Determination 2009/87

Determination regarding the code compliance of basement alterations to a house at 19 Fontenoy Street, Mt Albert, Auckland

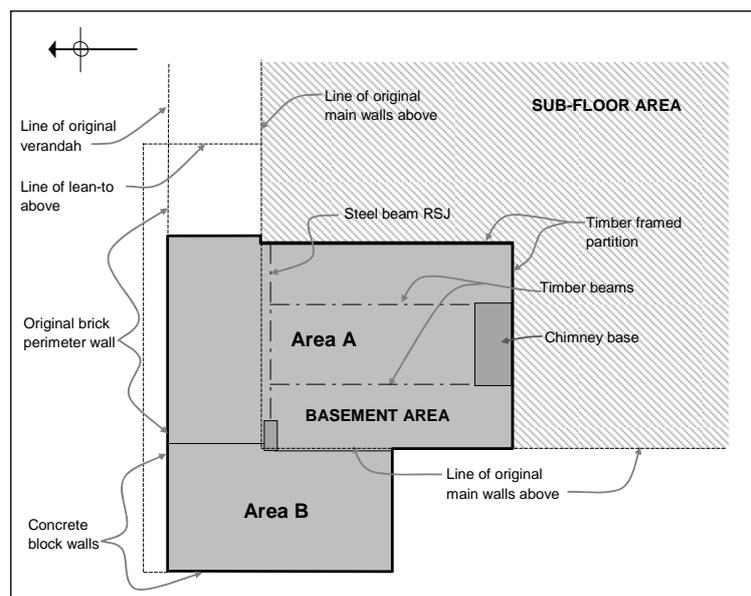
8.1 The designer maintains that the proposed alterations will result in the structure of the basement area being no worse than it was prior to the work. However, taking account of the expert's and engineer's reports, I consider that the following items require attention to achieve a minimum level of safety and/or compliance:

- the corrosion to the steel beam
- the inadequate timber beams above Area A
- the crack to the slab of Area A
- the vertical junction between the brick and concrete block walls
- the displaced concrete block to the exterior corner.

- 9.3 Taking account of the expert's report, I conclude that remedial work is necessary in respect of:
- the cracks to the junctions between the brick and concrete block walls

- the lack of adequate weatherproofing to the exterior doors, with associated moisture penetration apparent
 - the lack of adequate weatherproofing to the west timber window, with moisture penetration apparent.

- 10.3 Taking into account the engineer’s report, I therefore conclude that detailed structural investigation, with remedial work as necessary, is required to ensure the structural safety of the sub-floor in respect of:

- the concrete block sections in the perimeter foundation walls
 - the deflection of floor framing where jack stud supports have been removed
 - the capacity of the remaining jack studs and/or concrete piles for the loading

- the jack studs that are cracked, misaligned or supported on timber
 - the lack of sub-floor bracing, taking into account the age of the house
 - the inadequate connections between bearers, jack studs, and concrete piles.

- 11.1 A notice to fix should be issued that requires the owners to bring the building work into compliance with the Building Code, identifying the items listed in paragraph 8.1 paragraph 9.3, and paragraph 10.3 and referring to any further defects that might be discovered in the course of investigation and rectification, but not specifying how those defects are to be fixed. It is not for the notice to fix to stipulate directly how the defects are to be remedied and the house brought to compliance with the Building Code. That is a matter for the owner to propose and for the authority to accept or reject.
